Design aspects of the Strathfarrar and Kilmorack hydro-electric scheme

Mr L. H. Dickerson (Chief Civil Engineer, North of Scotland Hydro-Electric Board) congratulated the Authors for their valuable contribution to the records of the Institution. He said there were, in the scheme, several features not previously met with in other developments of the Hydro-Electric Board, and these were well described in the Paper.

FIG. 33

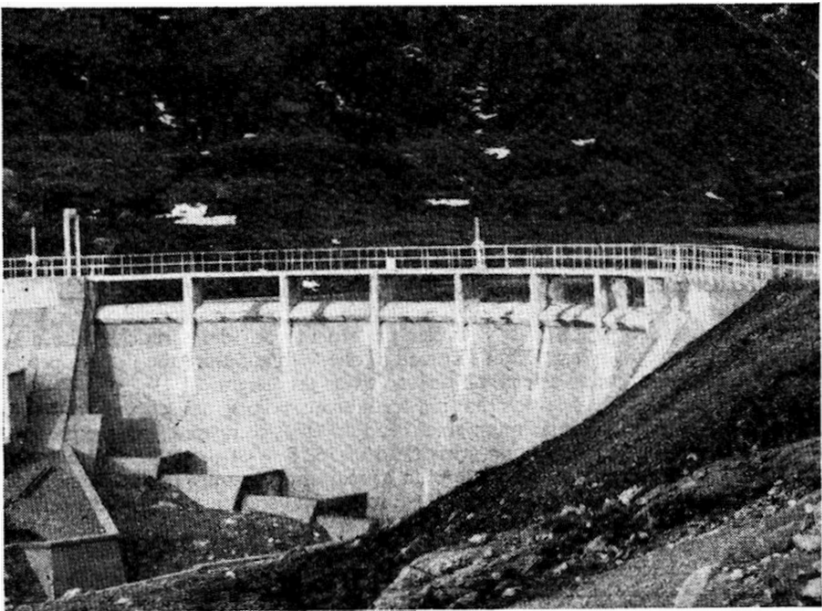
81. The design theory used at this dam at Chliostair was similar to that adopted at Monar but some additional simplifying assumptions were made. The Hydro-Electric Board proposed to investigate further theoretical stresses using an analysis based on the thin-shell theory developed by Dr S. R. Davies at Edinburgh University, and Mr Dickerson asked if the Authors had any similar ideas for the Monar dam.

137. The arch dam at Chliostair in Harris illustrated by Mr Dickerson (Fig. 33) had the distinction of being the first structural arch dam built in Britain and he was to be congratulated on the excellent job which he and his staff had made of it. When the Authors had examined it recently there had been absolutely no sign of seepage through the lift joints, a standard which was not often attained with comparatively thin concrete walls. This had been attributed to the successful use of PVC water stops in each lift joint. The rock on that site was not very strong and the measures adopted to eliminate erosion by water spilling over the crest were certainly justified.

FIG. 34

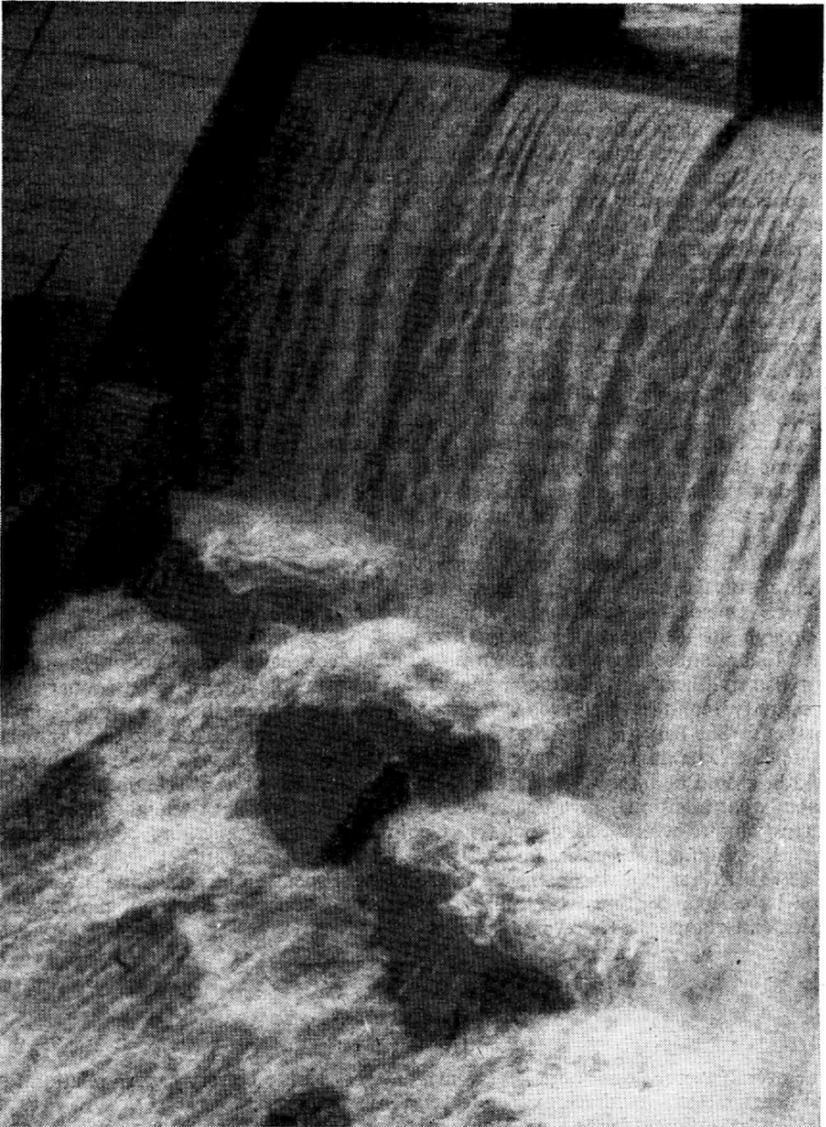
80. The design of the spillway arrangements at Monar with the tilting crest gates was a bold one, and he knew of no other arch dam where this principle had been used. It apparently involved complicated stresses in the upper arch ring. In discharging such large quantities of water to fall free from the crest, the quality of the underlying rock and concrete in the spillway channel and the downstream apron had to be good. In a small arch dam 50 ft high (Fig. 33), completed in 1963 on the Island of Harris and designed by the Hydro-Electric Board's staff, the rocks downstream were of doubtful nature and it was considered essential to provide some way of catching the water and dissipating as much as possible of its energy as it fell from the free overfall spillway. As a result of model experiments it was found that this could be effectively done with a series of small stilling pools around the foot of the arch (Fig. 34).

FIG. 41: INTERIOR OF KILMORACK POWER STATION

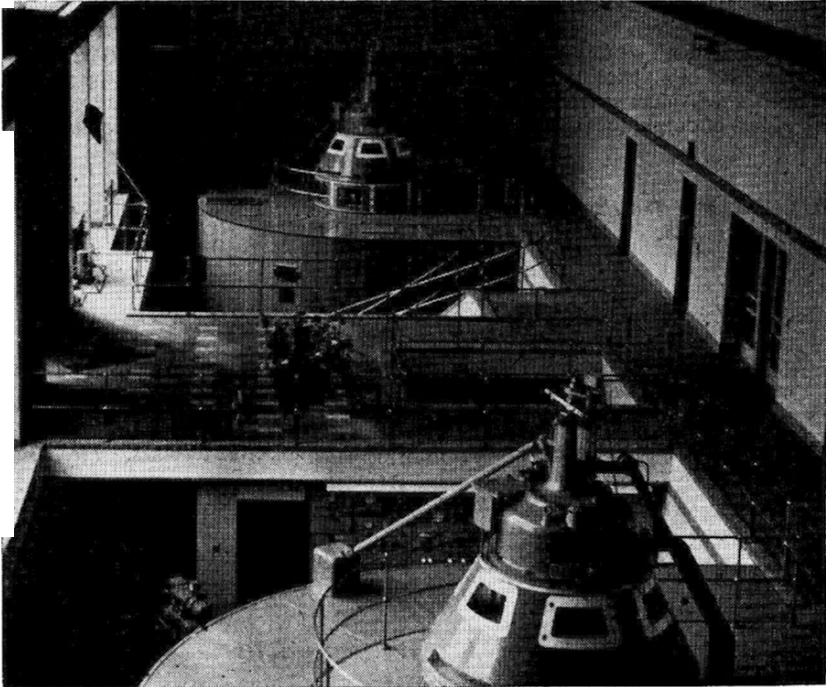
a common oil system for bearing lubrication and governor operation which simplified the problem of runner blade operation. Mr Coward thought, however, that the main advantage of this arrangement was that it obviated the need for an oil distributor head at the top of the shaft. There was no advantage at all in avoiding a hollow shaft and indeed the existing Culligran machine had a hollow shaft.

171. Mr Coward had been quite correct when he referred in § 100 to the advantage of using a common oil system for bearing lubrication and governor operation. The type of oil distributor head which had been dispensed with at Culligran could be seen in Fig. 41, which was a general view of the Kaplan machines at Kilmorack Power Station.
